Project	<b>IEEE 802.16 Broadband Wireless Access Working Group</b> < <a href="http://ieee802.org/16">http://ieee802.org/16</a> >	
Title	<b>Recirculation Letter Ballot 13a Comment 520 Reply</b>	
Date Submitted	<b>2004-01-13</b>	
Source(s)	Robert Nelson MacPhy Technologies 1104 Pittsburgh Landing Richardson, TX 75080	Voice: 972-239-9224 Fax: 972-671-1455 bob_nelson@ieee.org
Re:	Letter Ballot 13a on document <i>IEEE P802.16-REVd/D2-2003</i>	
Abstract	Discussion and suggested resolution to recirculation ballot 13a comment 520	
Purpose	Reply comment for comment 520 in LB13a comment database	
Notice	This document has been prepared to assist IEEE 802.16. It is offered as a basis for discussion and is not binding on the contributing individual(s) or organization(s). The material in this document is subject to change in form and content after further study. The contributor(s) reserve(s) the right to add, amend or withdraw material contained herein.

# Letter Ballot #13a

## Comment 520 Reply

**Figure 34—ARQ transmit block states**

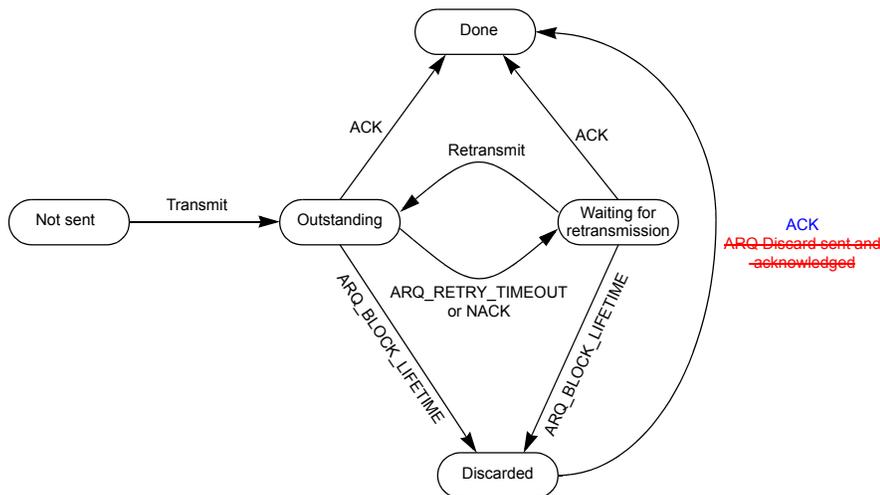
Accept suggested change. However, an error occurred during transcription of the diagram. The following figure includes the suggested change without the transcription error.

Page 132, Line 3: Replace Figure 34 with the following:

Figure 37—ARQ block reception

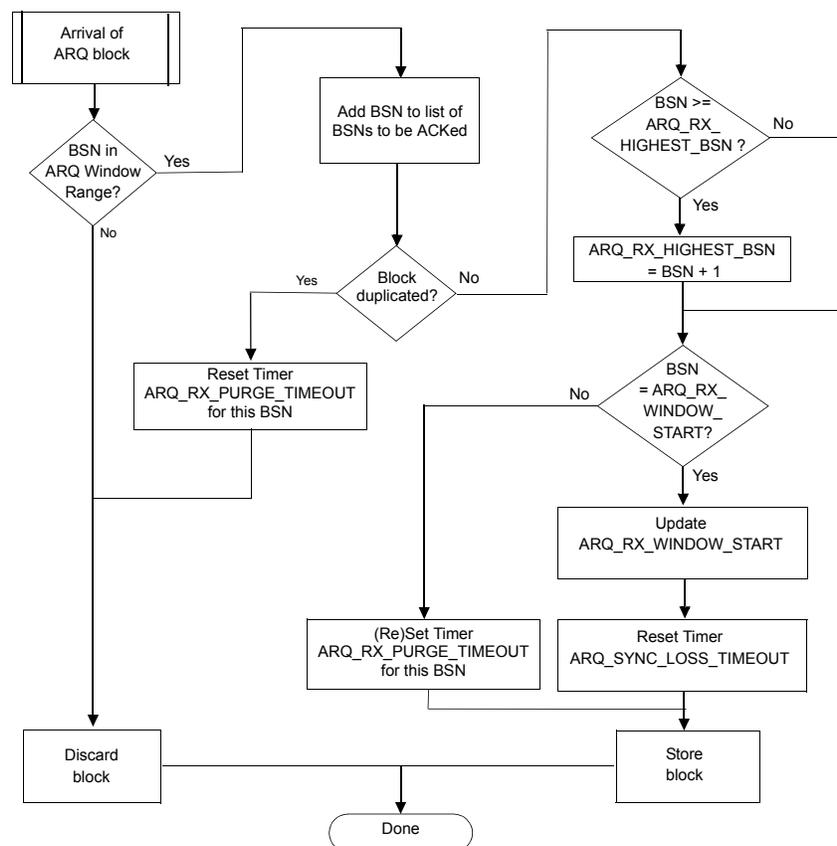
Assertions are made that there are problems with Figure 34 that are corrected by the submission:

The first issue is essentially that handling of *ARQ\_RX\_HIGHEST\_BSN* is not included in the figure. This is correct, the current diagram does not present the appropriate logic for updating this value.

The second issue is that the diagram improperly depicts handling of updates to *ARQ\_RX\_WINDOW\_START*. The assertion is correct. The diagram does match the corresponding text that properly describes the operation.

Also, an enhancement is proposed concerning handling of duplicate blocks.

The enhancement appears to be to short-circuit processing if a duplicate is detected and only take one action (resetting the purge timer for the block). This change is incorrect. Doing so results in no stimulus being provided to the receiver to initiate transmission of feedback ACK information. The fact that a duplicate was received indicates that a previous ACK transmission was lost, and the transmitter requires a new feedback IE transmission. Implementing the suggested logic suppresses possibly the only stimulus that could result in that transmission, potentially causing the state machine to lock-up.

The following diagram implements logic for managing for *ARQ\_RX\_HIGHEST\_BSN*, corrected handling for *ARQ\_RX\_WINDOW\_START* and appropriate handling on duplicate blocks.

Page 135, Line 13: Replace Figure 34 with the following:
